VALUE ENGINEERING MOD 1 TRAINING REPORT

Turner Hill/Rockland Road Widening

Project No. STP-0006-00(891)

March 11, 2009

I-3-1

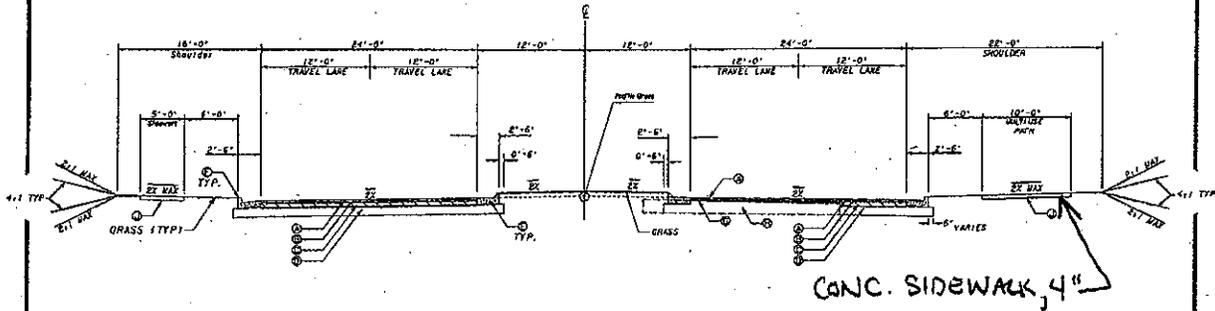
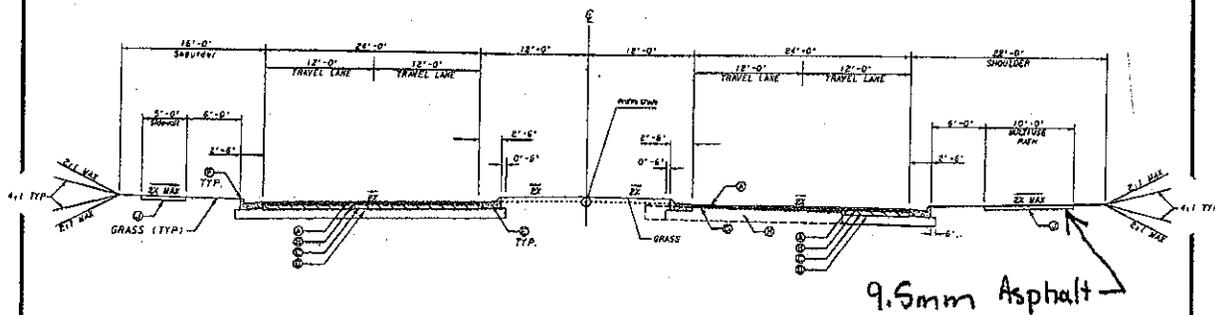
DEVELOPMENT AND RECOMMENDATION PHASE			
Project: STP-0006-00(891); PI 0006891; Turner Hill/Rockdale Road Widening			
Idea No.: I-3	Sheet No.: 1 of 4	CREATIVE IDEA: Utilize Asphalt for Multiuse Path	
Comp By: J.F. Date: 2-26-09		Checked By: Date: 2-26-09	
<p><u>Original Concept:</u> The proposed project calls for a 10' wide concrete multiuse path starting at Station 20+90 on McDaniel Mill Road. The path continues west toward Turner Hill Road then turns North and continues North on Turner Hill Road ending at Station 178+32. The current design has the path being constructed with 4" of PCC.</p> <p><u>Proposed Change:</u> It is recommended that the multiuse path be constructed of 4" – 9.5 mm asphaltic concrete instead of 4" of portland cement concrete sidewalk</p> <p><u>Justification:</u> The 10' multiuse path on this project is proposed to connect to a future multiuse path on McDaniel Road. The construction of a 10' asphalt multiuse path will reduce the cost of the project but still allow the same use of the 10' multiuse path. This change would reduce construction cost of the sidewalk and construction time.</p>

LIFE CYCLE COST SUMMARY	INITIAL Project Cost	FUTURE Project Cost	TOTAL Present Worth Cost
<u>INITIAL COST:</u> Original	\$393,000		
Proposed	\$270,000		
Savings	\$123,000		
<u>FUTURE COST:</u> Savings			
TOTAL PRESENT WORTH SAVINGS			\$123,000

<p>2010 Base Year Peak Hour Conditions</p>	<p>Turner Hill Road Widening</p>	<p>Figure 4</p>
--	---	---	----------------------------

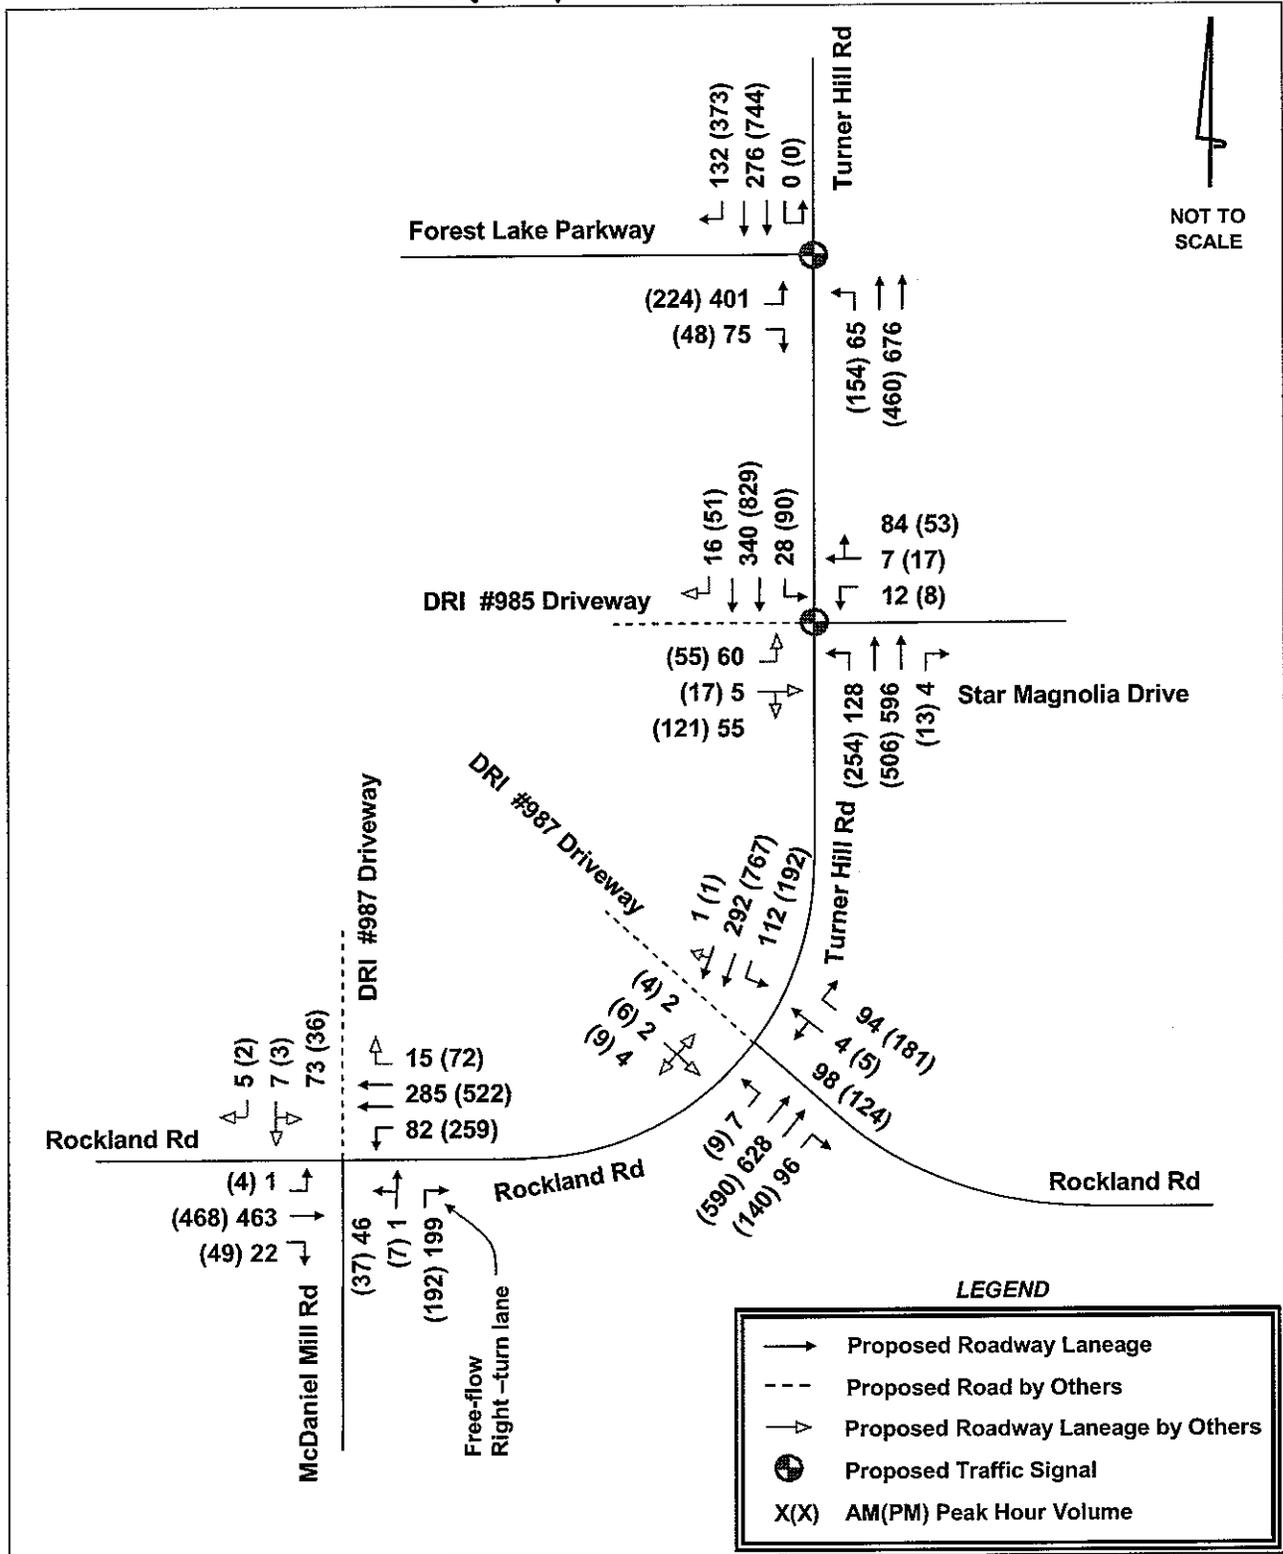
DEVELOPMENT AND RECOMMENDATION PHASE			
Project: STP00-0006-00(891), DeKalb Co.: Turner Hill Widening			
Idea No.: J-1	Sheet No.: 1 of	CREATIVE IDEA: Eliminate Signal @ Star Magnolia Dr.	
Comp By: Nicoe Alexander Date: 2/26/09 Checked By: Team 1 Date: 2/26/09			
Original Concept: The project proposes two new signal installations			
Proposed Change: It is recommended to remove the signal at the Turner Hill Road/Star Magnolia Dr. intersection be removed.			
Justification: The design proposes to install the signal at this location with the DRI driveway forming the fourth leg of the intersection. This future development is proposed and will not be constructed prior to the letting of this project. Although a signal may be needed after this development, it is not warranted as part of this project. This intersection has an acceptable LOS in the base year without the proposed signal and future development.

LIFE CYCLE COST SUMMARY	INITIAL Project Cost	FUTURE Project Cost	TOTAL Present Worth Cost
INITIAL COST: Original	\$ 316,620		
Proposed	\$ 211,080		
Savings	\$ 105,540		
FUTURE COST: Savings			\$106,000
TOTAL PRESENT WORTH SAVINGS			\$106,000
